Service-Information Motorcycle

Fuel Tank
And Lines

16 015 87
(2244)

Fuel Cap Dust Lip Chafing Fuel Tank Surface - Boxer Models

Fig. 1

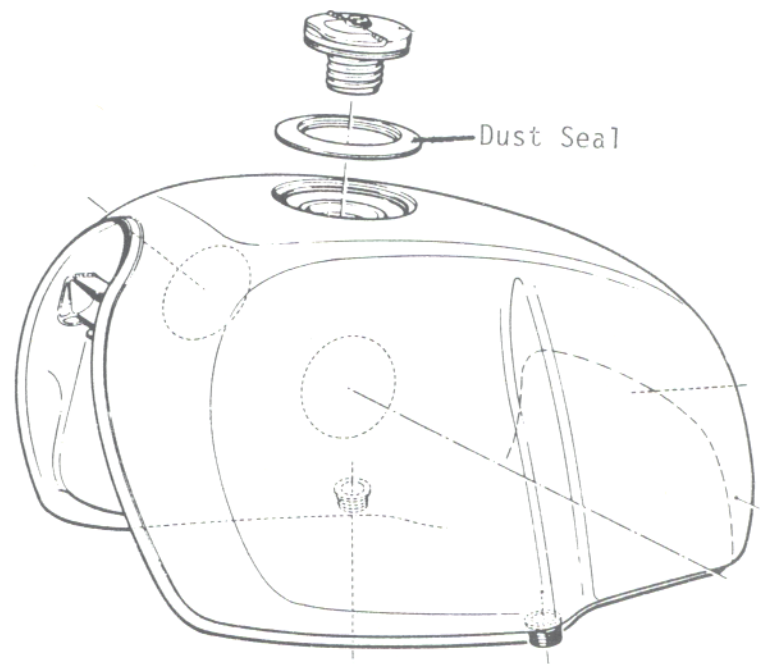
Information: To prevent fuel tank's painted surface from being rubbed or chafed by the Dust Seal (Fig. 1), an O-Ring 44 x 4 mm (Part No. 11 42 1 337 098) can be fitted between the sealing surfaces as shown in Fig. 2.

The O-Ring will restrict compression of the fuel cap seal, raising the overall cap height when tightened, thereby preventing the Dust Seal from rubbing against the painted surface.
